ELECTRONICS FIELD CHANGE BULLETIN	AN/FRT-39
BUREAU OF SHIPS, NAVY DEPARTMENT	AN/FRT-40
WASHINGTON, D. C.	AN/FRT-62

**PURPOSE:** This modification provides remote on/off control of the transmitter carrier. In addition, the unit provides an indication of transmitter status by means of signals to a display board located at the transmitter monitor control console or elsewhere at the transmitter site. In order to accomplish this modification, Tone Intelligence Unit Model TIS-3 is physically replaced by Transmitter Keyer Monitor Control Unit, Model KMCU-1. Tone Intelligence Unit TIS-3 will be relocated to the CCL facilities at the transmitter site or to some other remote location.

TEMPORARY CORRECTION TO TECHNICAL MANUAL FOR RADIO  
TRANSMITTING SETS AN/FRT-39, AN/FRT-40, and  
AN/FRT-62

FIGURE 3

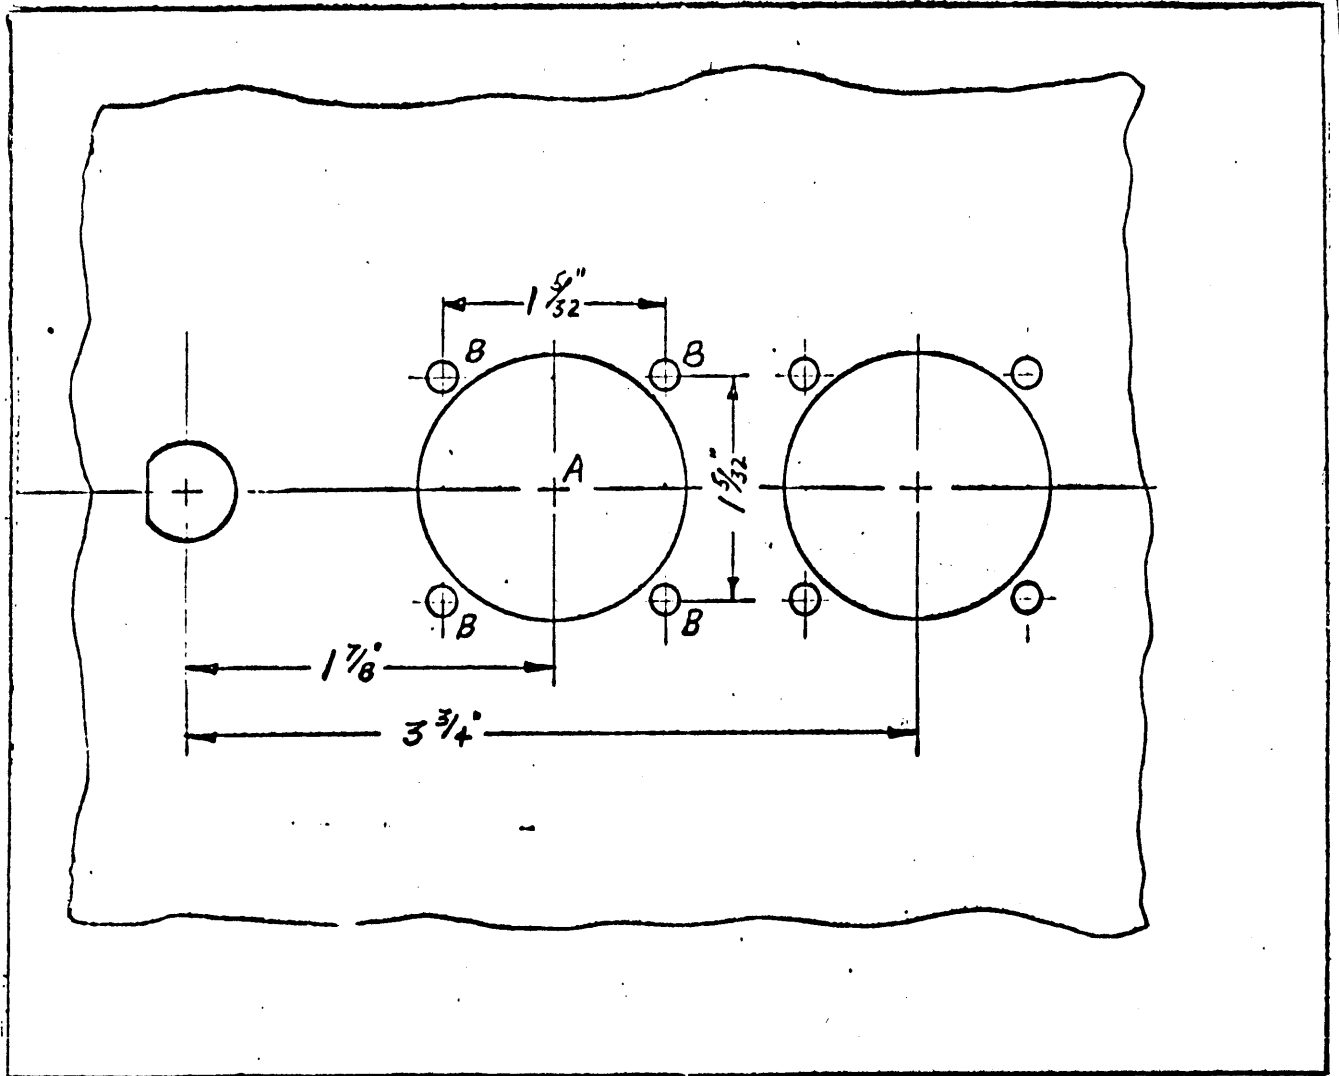
- (a) Mark MS-3679, using Figure 3 for dimensions.
- (b) Using the 9/64" drill bit, 3/8" drill bit and the 1-5/16" chassis punch, modify MS-3679 as shown in Figure 3.
- (c) Using the stamps provided, stamp J-1010 on both sides of the shield and P-3054 on the auxiliary frame side.

A - 1  $\frac{5}{16}$ " DIA. 1 REQ.

B -  $\frac{9}{64}$ " DIA. 4 REQ.

FIGURE 4

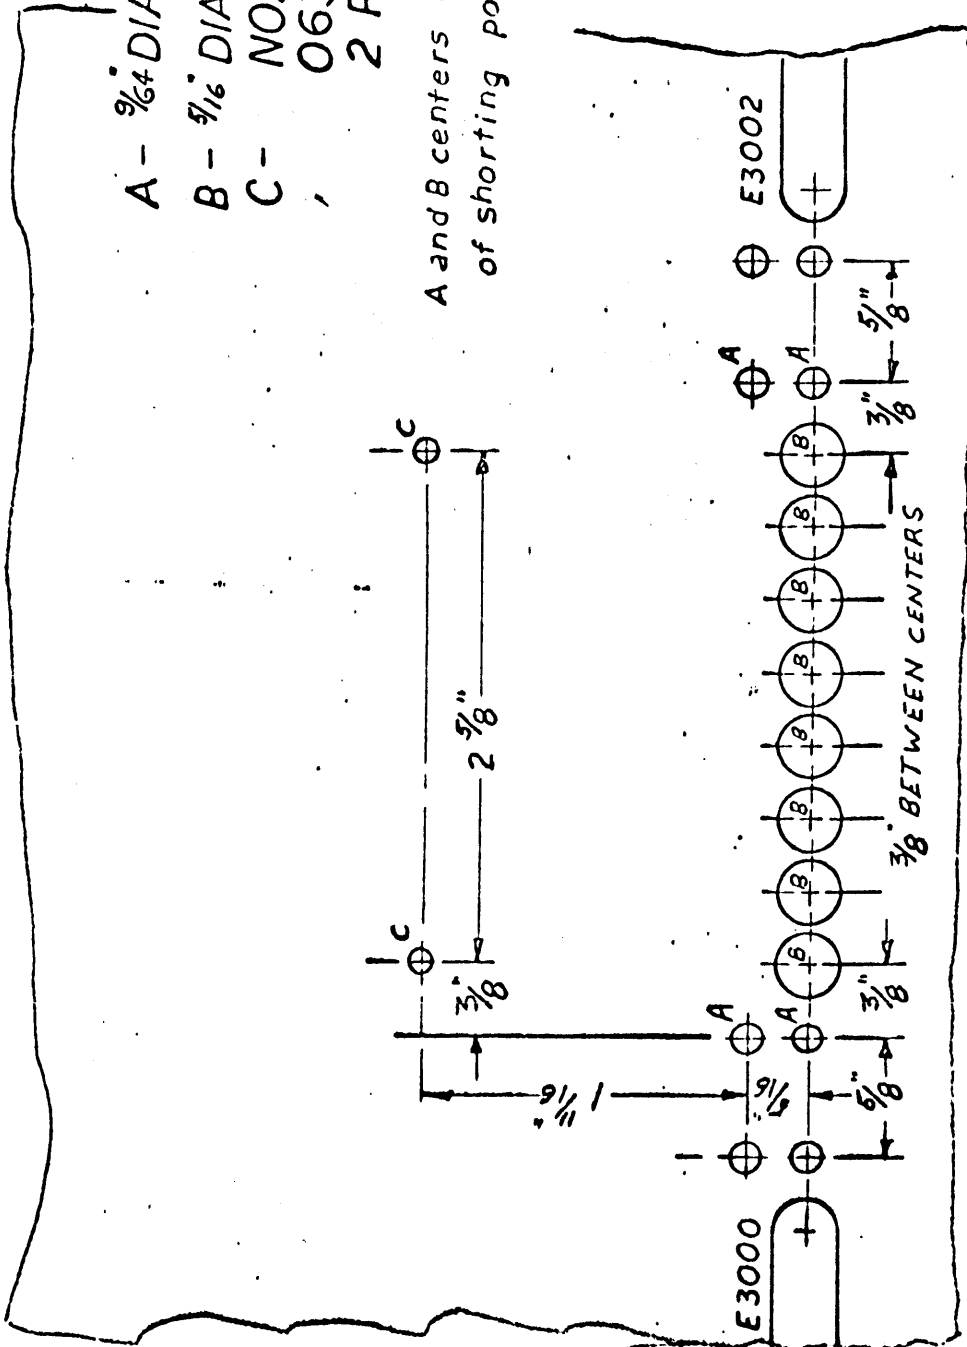
- (c) Mark MS-2469, using Figure 4 for dimensions. Using the 9/64" 5/16" and the No. 36 drill bits and the 0632 UNC Tap, modify MS-2469 as shown in Figure 4. Using the terminal strip, insulation paper, 2 saddle plates, 4-5/8" 4-40 screws, 4 nuts, 2 lock washers and 2 ground lugs, mount the terminal strip, identically as E3000 and E-3002 position on the center shield. Mount the UG-274/U "T" to the feed thru on the equipment side. Cut the removed J-3002, (JJ-172), from the cable. Connect the PL-169 to this cable. Connect this PL-169 to the "T" on the equipment side of the center shield, solder the No. 16 buss wire, to the ground lugs as is done on the other strips. To seven lugs of the strip, running consecutively right to left from No. 14 of E-3000, connect the 1000 MMFD capacitors. Connect the other end of the capacitors to the ground buss as is done on the other strips. To the eighth lug, connect a length of No. 22 buss wire to the ground buss. Position the connections on the terminal strip lugs to leave enough clearance to connect the cable in a following step. Using the stamps provided, stamp the center shield as shown in Figure 5.

- A -  $\frac{9}{16}$ " DIA. 4 REQ.
- B -  $\frac{5}{16}$ " DIA. 8 REQ.
- C - NO. 36 BIT  
0632 UNC TAP  
2 REQ.

A and B centers critical because of shorting possibility.

FIGURE 6

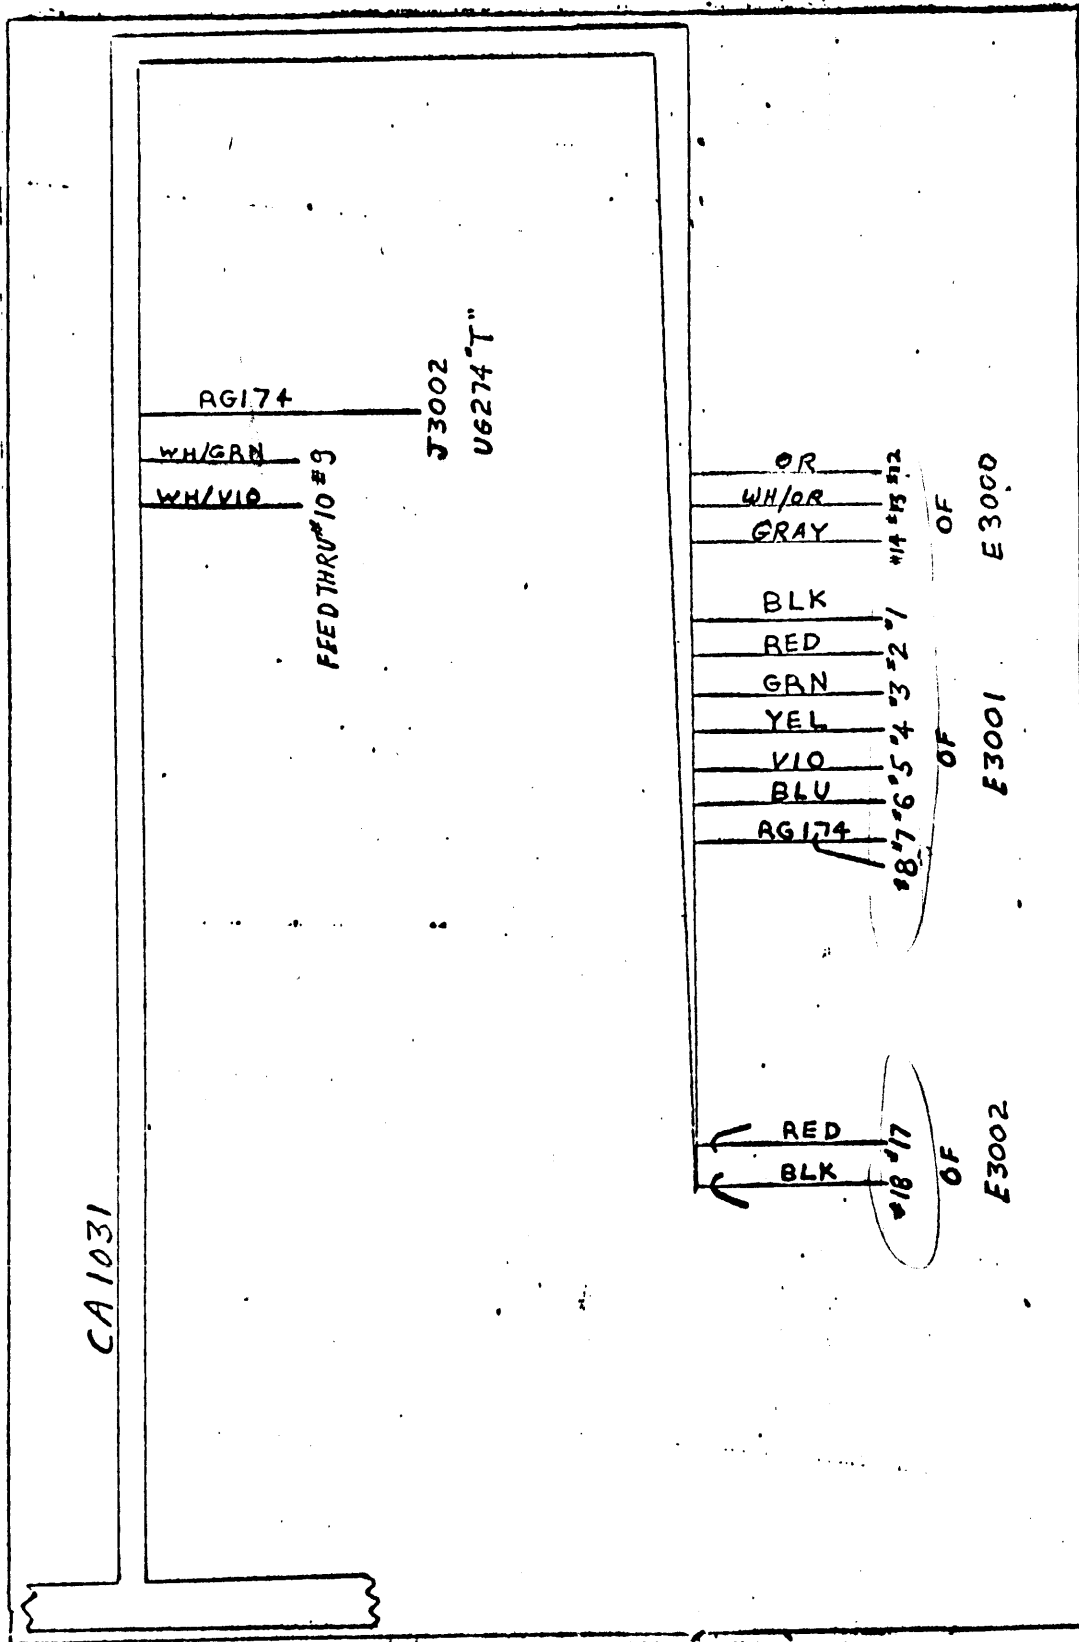
- (a) Align the center shield breakout of CA-1031 with the center shield breakout of the main cable. Lace the two center shield breakouts together. Connect and solder the leads as shown in Figure 6. Along the main cable, lace the KMCU breakout to the cable as far as the TIS breakout. Do not lace the KMCU and TIS breakouts. Lace the CHG breakout along the main cable and the CHG original breakout. Leave enough slack at the plug to allow free movement during connection.

FIGURE 1

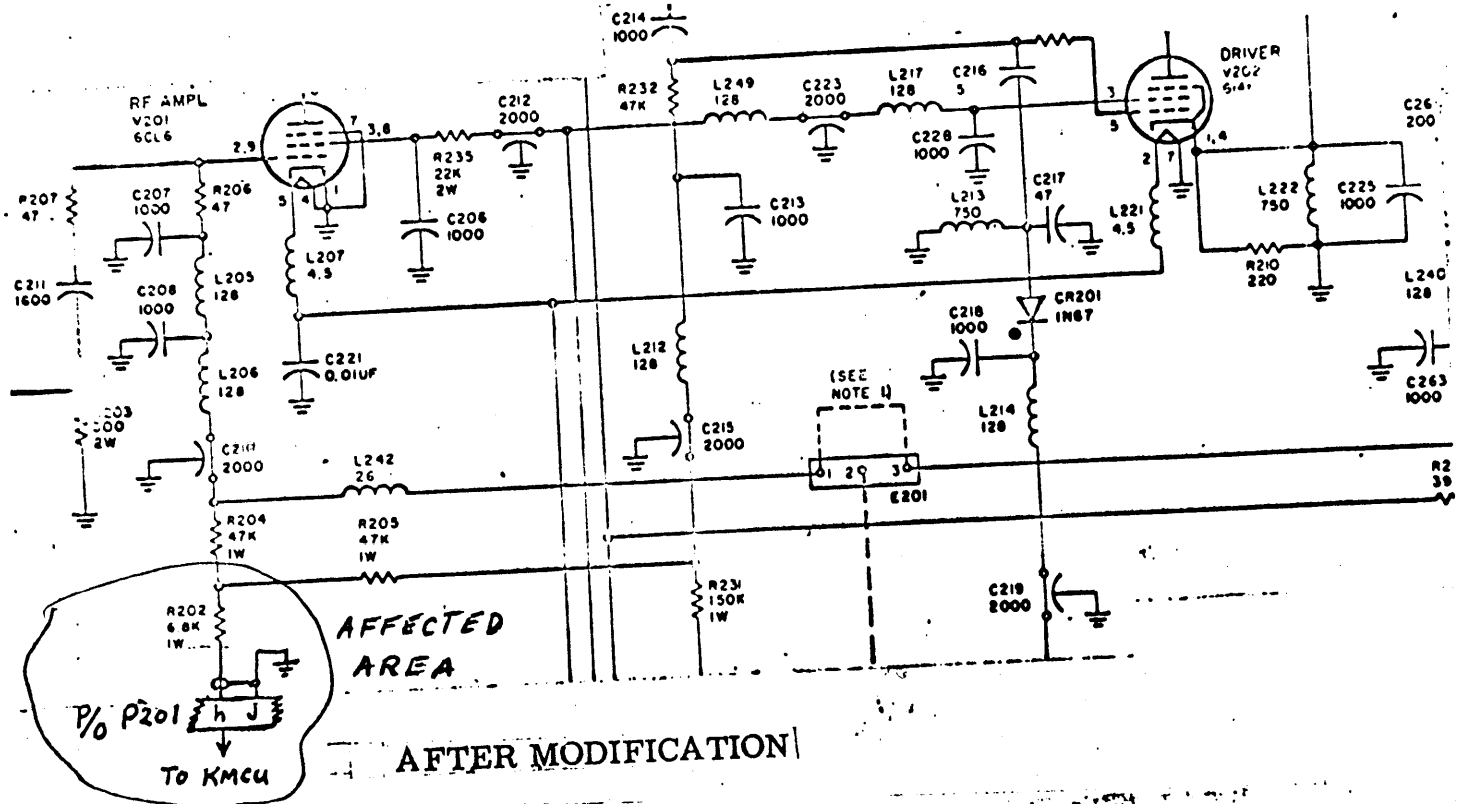
b. SCHEMATIC DIAGRAMS (Section 6). - Schematic diagrams given in Section 6 of the maintenance manual should be ammended as shown in figures 1, 2, and 3.
